**From:** [REDACTED]  
**Sent:** 28 April 2025 16:35  
**To:** planninginfo  
**Subject:** DM/25/0014, DM/25/0015, DM/25/0016 and DM/25/0017

These comments follow review of the various updated documents associated with the planning application DM/25/0014 , DM/25/0015, DM/25/0016 and DM/25/0017. All planning numbers noted above are relevant for the comments below.

### **Re: Framework Travel Plan**

##### 3.3.1 Bus

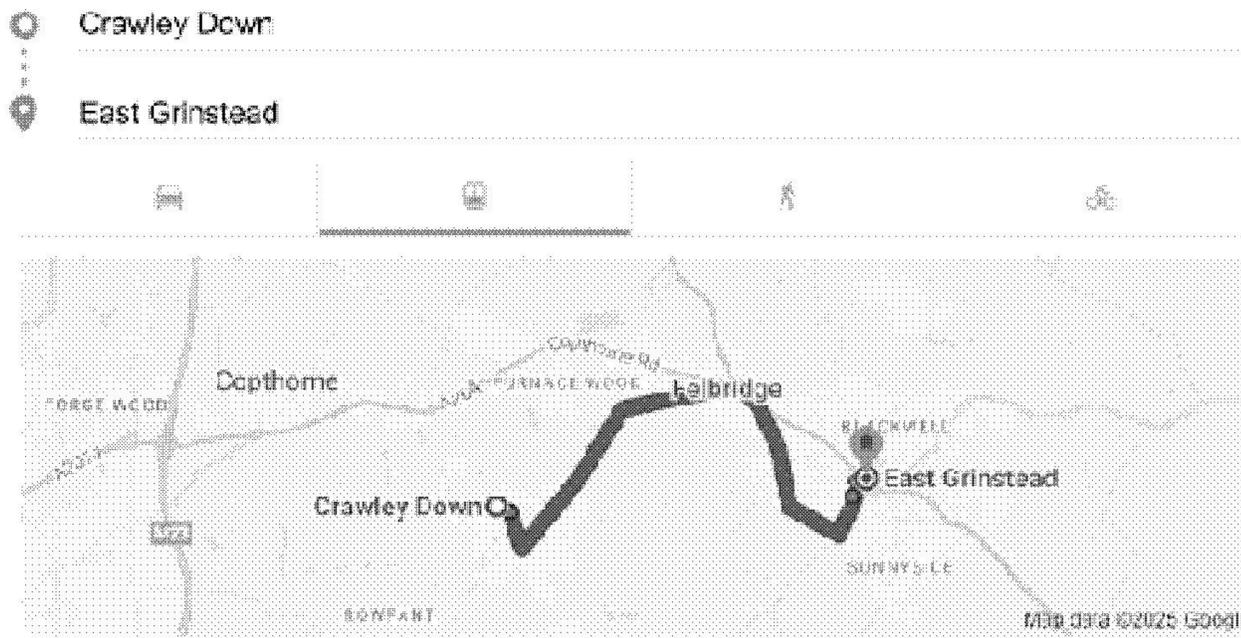
Bus stops described as 600m from 'the site'. Is this misleading?

The site itself is approx. 700m East-West the bus stop is therefore a 10 – 15 minute walk away from the 'average' house location on this site.

#### 3.3.7

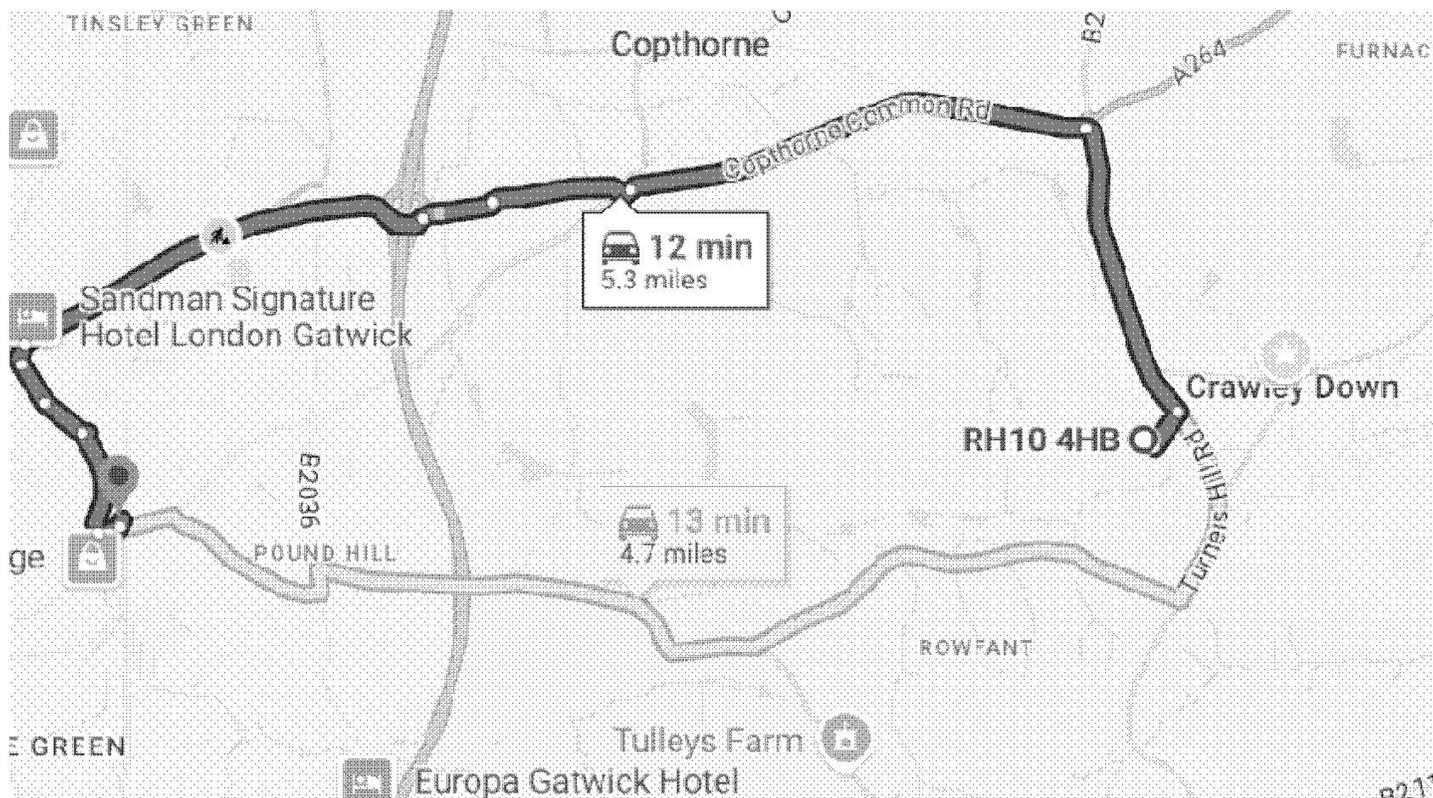
Inaccurate distances stated 'approximately 5km to Three Bridges station'. It is in fact 7.6km (4.7miles shorter journey shown below).

### 3.38

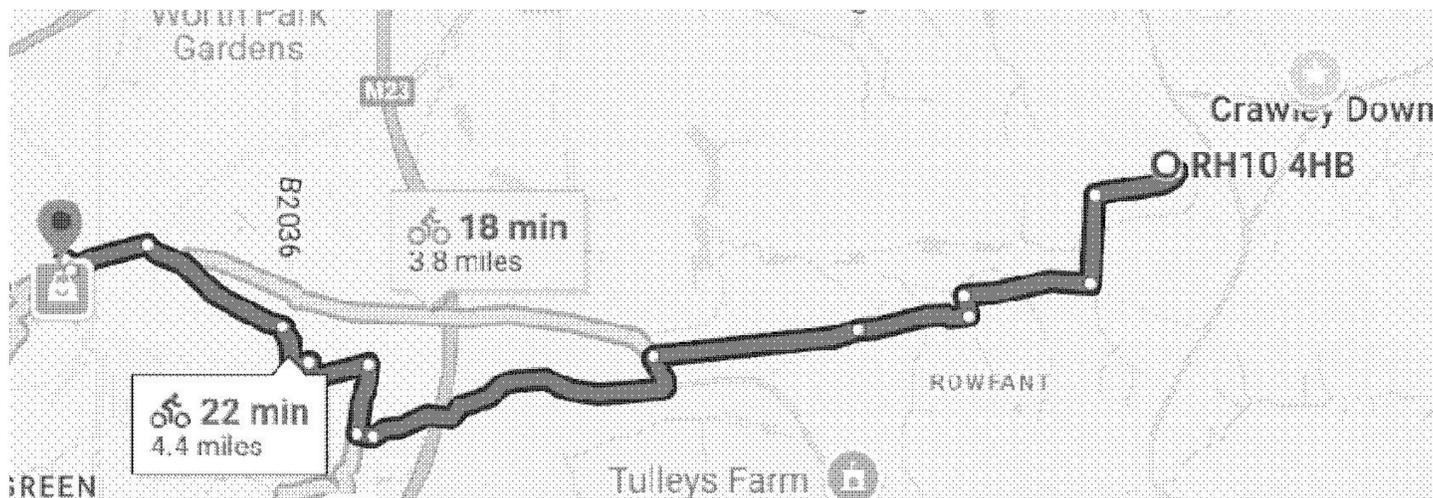
Inaccurate data claimed about cycle time to Three Bridges station:

“ Three Bridges and East Grinstead are accessible by bike via Worth Way (approximately a 15-minute cycle ride to Three Bridges “

See below for estimate of 22 minutes to Three Bridges along the Worth Way from Huntsland

In **WSCC Response Note** Appendix A Scoping Note 044 Traffic Modelling

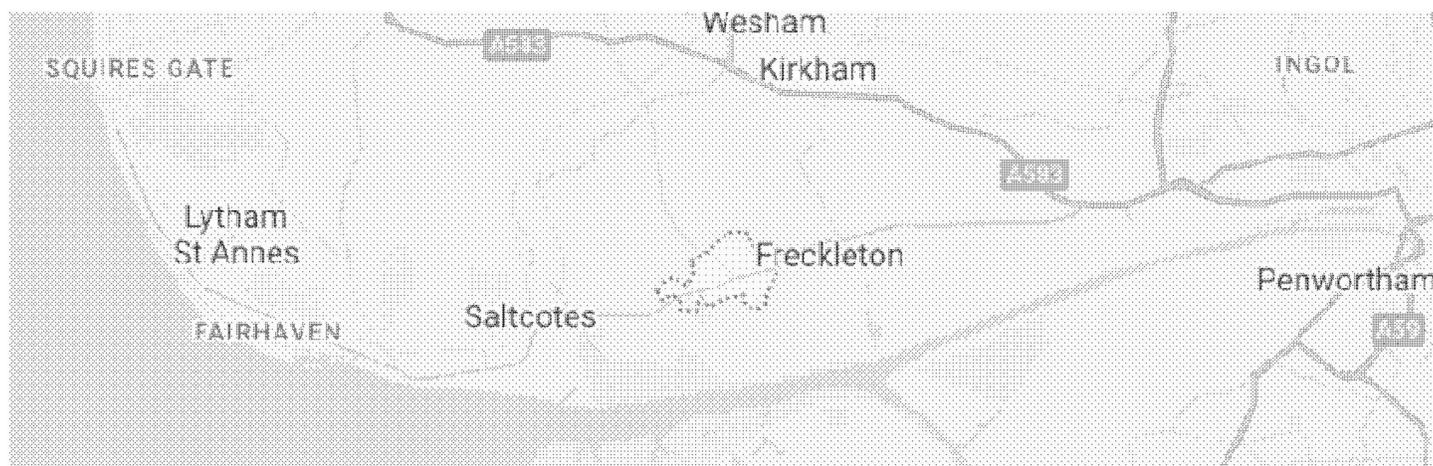
i. When discussing whether 'severe' impact will be experienced at local junctions by the development, a previous case is cited.

References a case where development of 350 dwellings was reviewed and considered not to contribute severely to road user experience.

This location is not a reasonable comparison with Crawley Down. See the dotted area on the map showing the village in question. The road is described as a coastal route, despite being an A road, Not a major cut-through road North-South near a busy London airport.
